**Application for a Development Consent Order for the Thanet Extension Offshore Wind Farm (EN010084).**

We write in response to the letter dated 21 November 2019 from the Department for Business, Energy and Industrial Strategy ('the Secretary of State').

The Applicant has provided comments on the responses submitted by Interested Parties (IPs) on the Collision Risk Model and 2019 Pilot Transfer Bridge Simulation in Annex A and Annex B. A final summary position on shipping and navigation, taking into account the conclusions of the 2019 PTBS and the latest responses from IPs is submitted in Annex C.

Figure 1 Representative ‘screen grab’ derived from the ‘pilots’ busiest day animation (Annex A to Appendix 5 of the Applicant’s Deadline 8 submission)

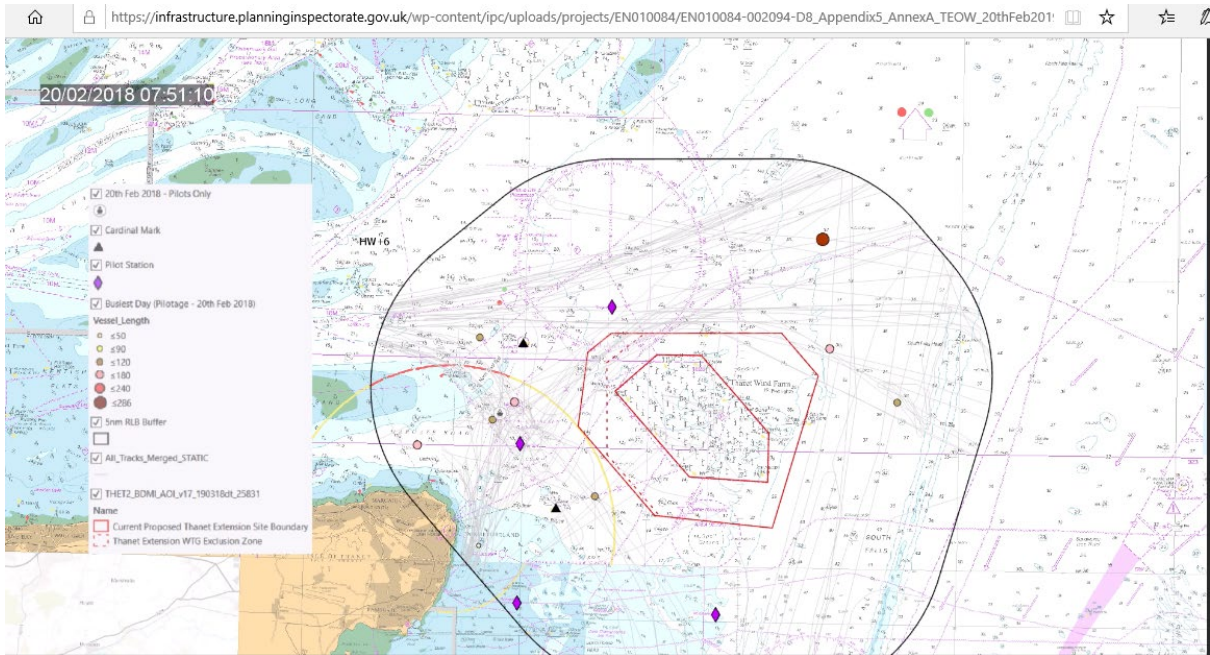
- 28 The limit state nature of the simulations with regards traffic conditions is evidenced by reference to the AIS animations, which provide graphical representation of the busiest 24hr periods recorded during a 12 month period. Figure 2 provides a ‘screen grab’ of the busiest 24hr period for [pilotage](#) (Annex A, Appendix 5 to Applicant’s Deadline 8 submission), and is directly comparable with the scenarios simulated noting that the simulation compressed this traffic into a 1hr period (Figure 1). It can be seen that the number of vessels and their proximity around the NE Spit pilot diamond and the inshore route in general is comparable, although more vessels are present in the simulation (Figure 2), emphasising the precautionary nature of the PTBS.

Figure 2 Pilot transfer plot (Run 12) taken from Applicant's 2019 PTBS submission

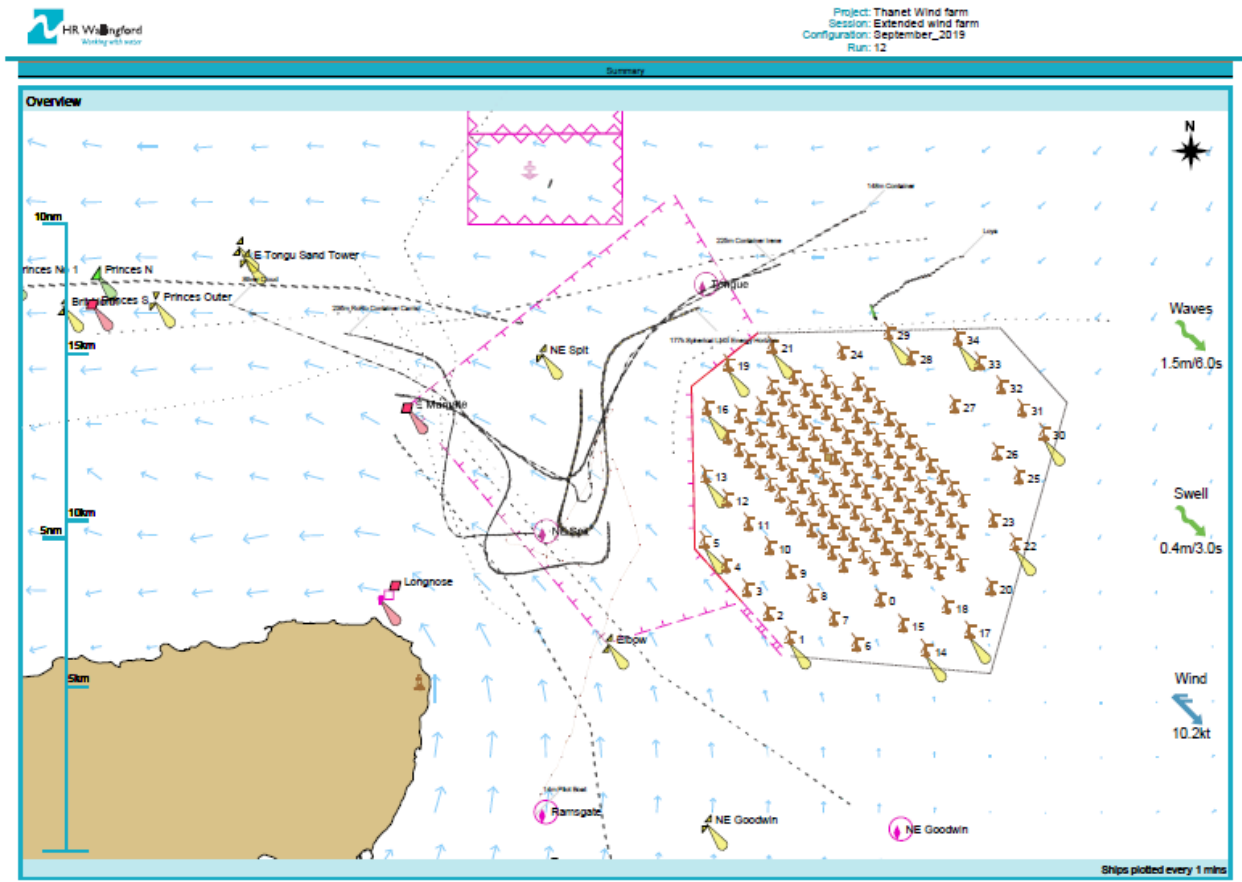
- 29 The limit states with regards vessel sizes is clearly evidenced by the simulation of a range of vessels inclusive of those recognised by all parties as not currently using the inshore area, but which may potentially, under specific conditions, use the area in the future.
